**To:** Development Permit Panel

**File:** DP 13-645286

**Re:** Application by Andrew Cheung Architects Inc. on behalf of 684267 B.C. Ltd for a  
Development Permit at 8151 Anderson Road

PROJECT <b>8151 ANDERSON ROAD RICHMOND</b>	FILE NAME <b>EAST ELEVATION - BUSWELL STREET</b>
PROJECT NUMBER <b>21212</b>	CHECKED BY <b>AC</b>
DRAWN BY <b>AC</b>	SCALE <b>1 : 100</b>
DRAWING NUMBER <b>DP 3.2</b>

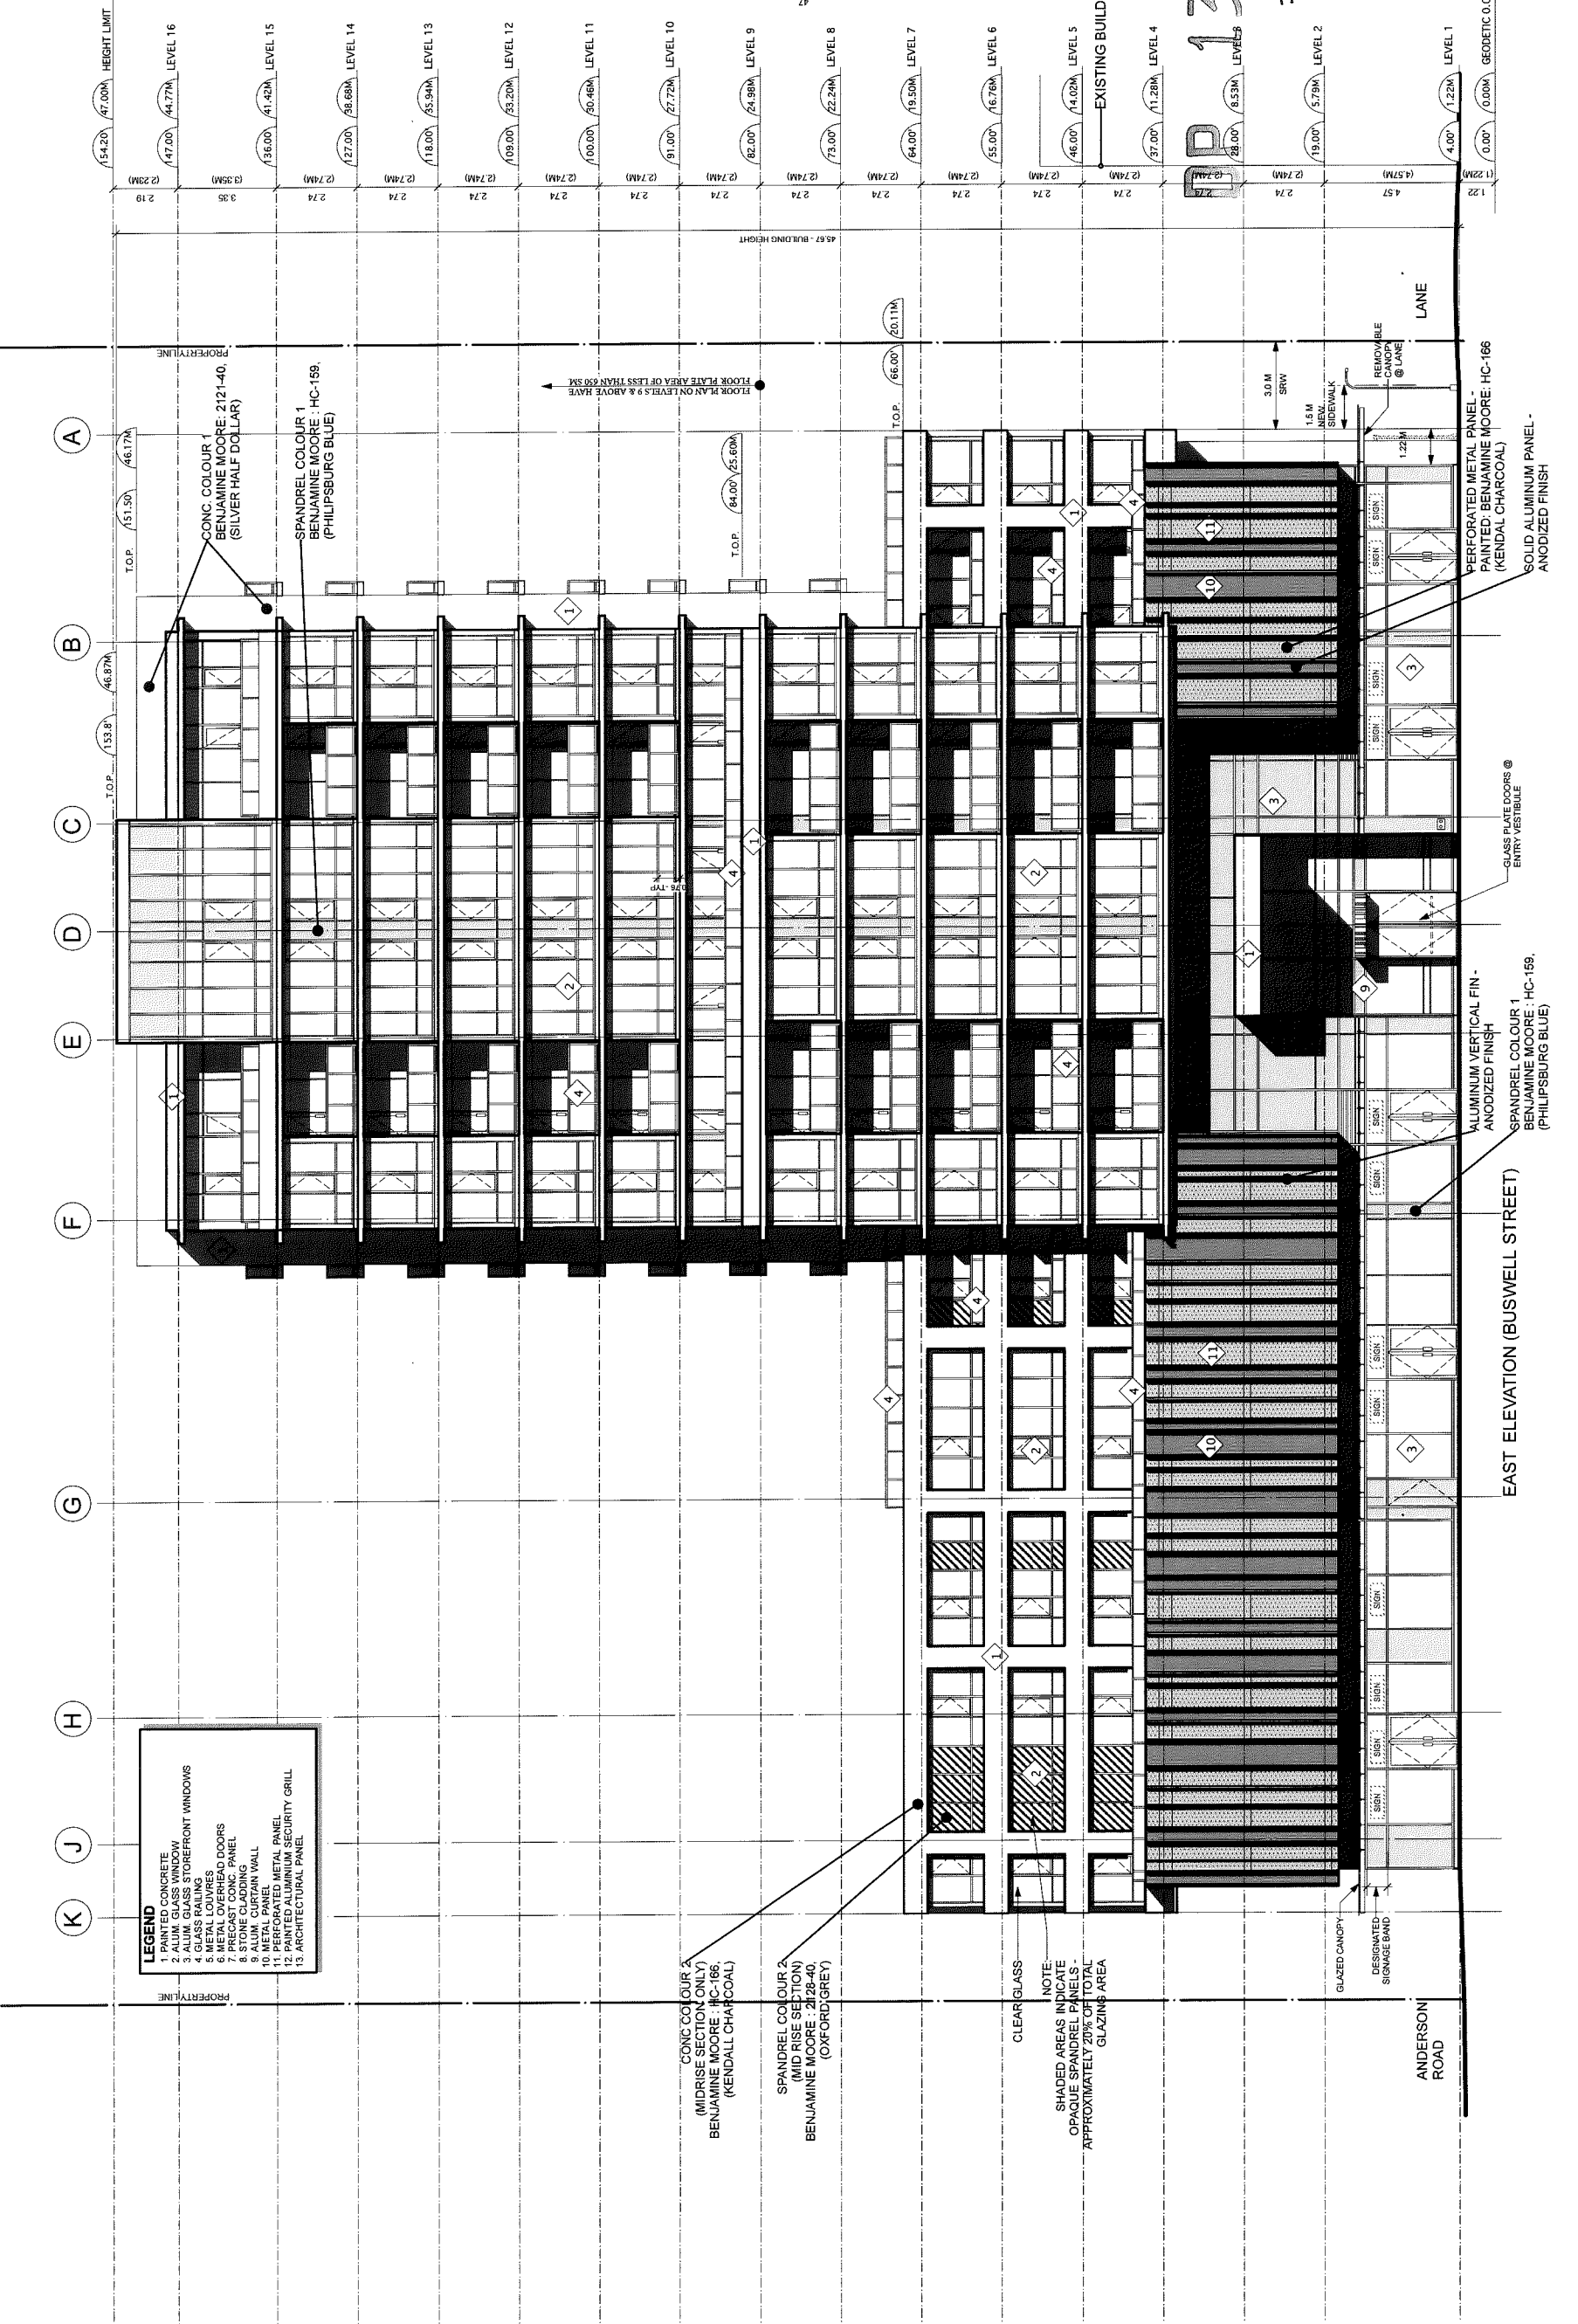
- agree with previous comment regarding the tower form getting lost in the lower portion which projects out along Buswell Street; needs to be “cleaned up” and refined to maintain the purity of the tower form;  
*We have revised the projections, eliminating the smaller single projection of the parking volume at Buswell Street. The “projection” has been extended to both sides of the entry hence marking the entrance as a recess.*

- retail frontages are handled well; transparency of a large corner retail element works well; however, this character is not carried through the Buswell Street elevation; canopy above the left-over retail spaces appears heavy; consider transitioning back to the typical glazed canopy in order not to conflict with the entry to the residential lobby;  
*As noted in previous comments, the canopy over the main entry has been revised, and the canopy over the north retail unit along Buswell Street has been changed to a glazed canopy.*
